To: Belfast Planning Board

From: Upstream Watch Consultants

**RE: Response to Ms Olver October 10, 2020 Report:
Nordic Aqua Farms Waste Water Discharge Review**

Date: October 15, 2020

Exhibit 1 Asymptotic steady state predictions of time series areal dilution at the environmentally sensitive region containing diluted effluent with the median age of 1.5 – 2.5 days old. The $10^{2.5}$ line represents $\sim 300:1$ dilution for the Green 50th percentile.

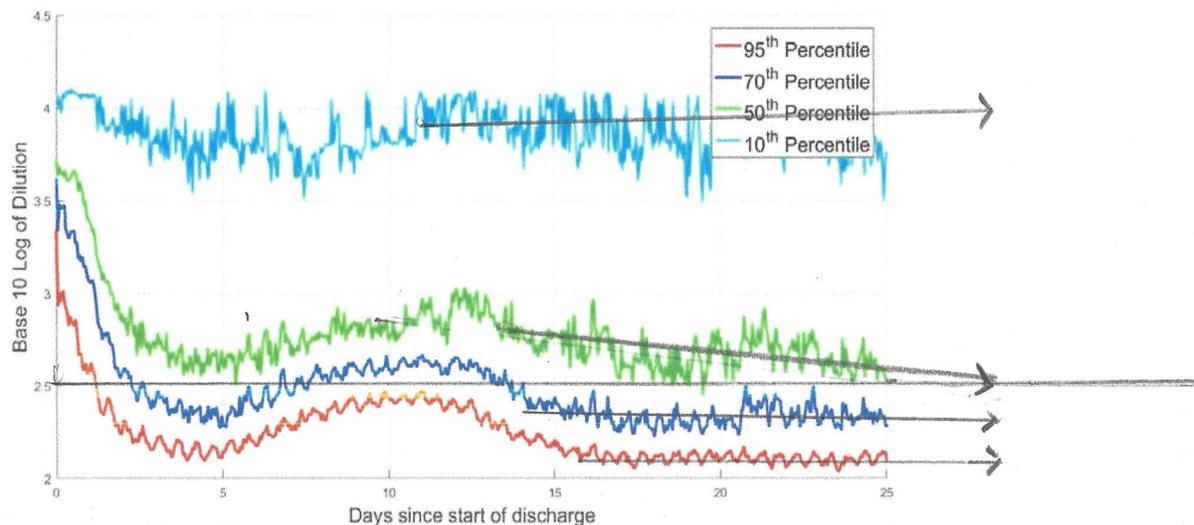
2. The point of using these models of different percentages of the areas with predicted dilution is to view what the longer-term equilibrium value will be. The 25-day model for the different area percentage to reach equilibrium suggests that the lower dilutions tend to be reaching equilibrium (or a more steady state) at less than 50%. The 70% line (meaning 30% of the area will have a dilution less 160:1) is clearly showing a leveling out by 25 days.

3. To arbitrarily pick a fortnight of time that includes a tidal variation (high and low tides and tidal wave interference) before equilibrium is being reached in Figure 2 is cherry picking of data in an attempt to provide a desired result. Indeed, the way that Dill and others have originally referenced their Exhibit 23 was the statistical way to predict a steady state longer term dilution for a certain location over time. It is the end time that we seek, not the times of tidal oscillations before equilibrium is modeled. Depicted below as Exhibit 1 is a markup of Dill's Figure 2. Here, the approximate asymptotes of the data for each of the represented % areas are penciled in. The asymptote line represents the predicted end point of the final dilution value beyond the 25.45 days when the dilution has reached a more steady state equilibrium. Nordic has now suggested to use instead a cherry picked portion of the graph with a higher dilution than the steady state longer value.
